AP = 1524 Congress . treet

Amer—Admund & Lthel Luce 1524 Congress St. Contractor—1. G. Johnson Co. 3 Cliff St.

AP 1524 Congress Street.

Building permit for construction of a single family dwelling 26 feet by 32 feet at 1522-1524 Congress St. is issued herewith based on plans filed with application for permit, but subject to the following conditions:walna

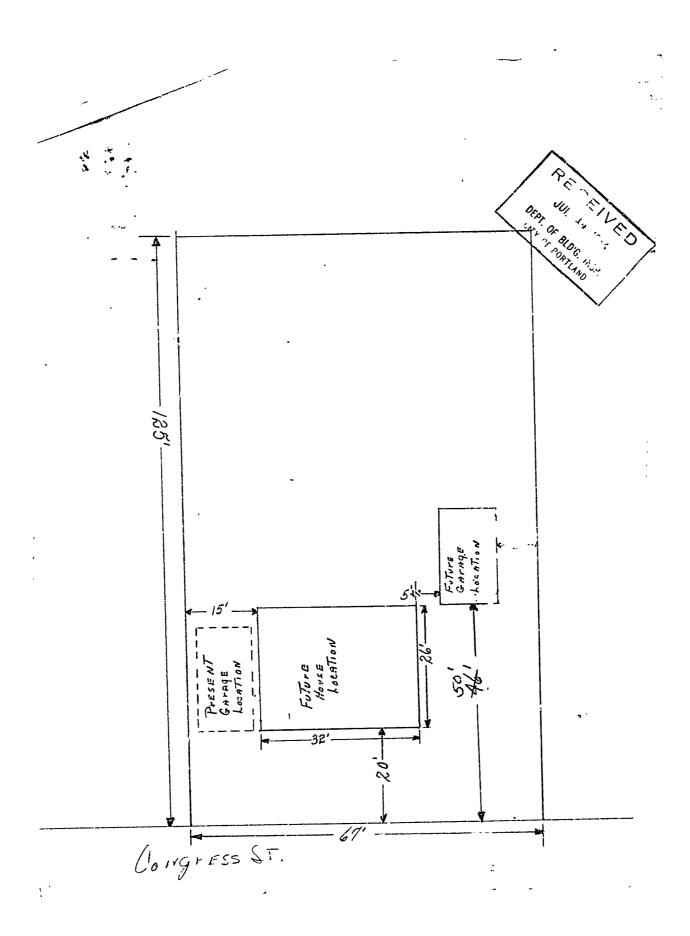
-before notice is given for checking of location and forms, street 4x6 salls line and grade is to be procured from and staked out by the Department of Public Works; and information is to be furnished as to foundation and framing of rear platform.

--protection is to be provided on inside face of walls of existing garage wherever they will be closer than five feet to any enclosed part of the new dwelling as indicated on plot plan. -by acceptance of permit you agree to provide construction as indicated below as regards the following details:-

> ----use solid 6x10 girder instead of built-up girder as shown on plans.

> provide solid corner posts rather than construction shown on plans. use alternate sill construction indicated on plans.
